LumiraDx

February 03, 2021

**Field Safety Notice.**

**Mandatory Software Update LumiraDx SARS-CoV-2 Ag Test**

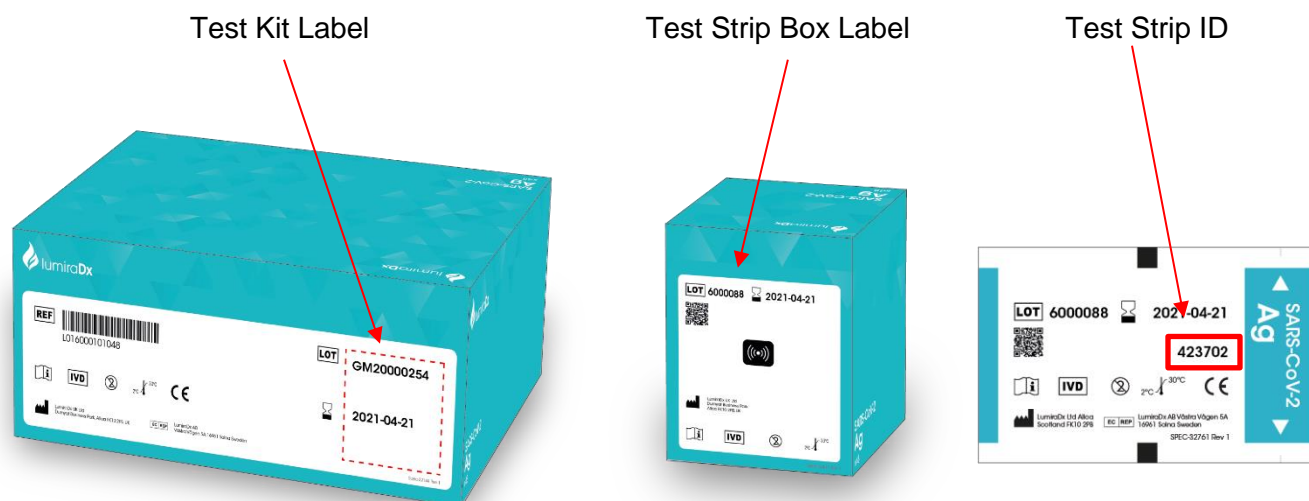
See the Test Strip Kit label and Test Strip pictures below for ease in identifying affected Test Strips. The affected Test Strips in each lot can be identified by their serial number. The Serial number is a 6-digit number and the first digit can be either 1, 2, 3, or 4. Only the Test Strips in the serial number range listed in the table above are affected by this issue. **Following this mandatory software update, affected Test Strips will automatically be recognized by the Instrument as invalid and will not need to be manually identified. Test Strips outside the affected serial number ranges for each lot will run normally when inserted into the Instrument.**

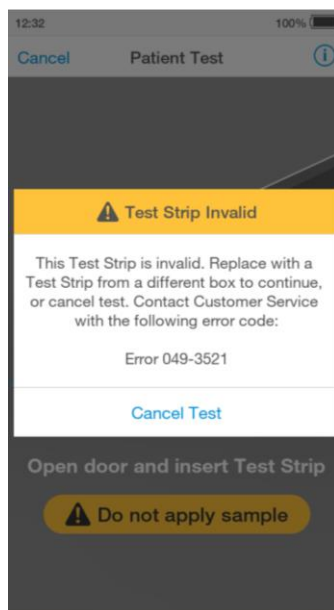
To continue testing with LumiraDx SARS-CoV-2 Ag Test, software version 1.21 must be installed immediately. This is a mandatory software update to ensure only valid Test Strips are used. The software identifies the specific Test Strip ID numbers that have a potential to indicate false positive results and prevents the tests from being used. When a user inserts such a Test Strip, the Instrument will instruct the user to discard the Test Strip and the remaining Test Strips from its opened box – see invalid Test Strip screen image below. Please note, LumiraDx will replace all affected Test Strips free of charge.

This software update includes lot calibration files introducing additional error-checking measures to minimize any potential for false results.
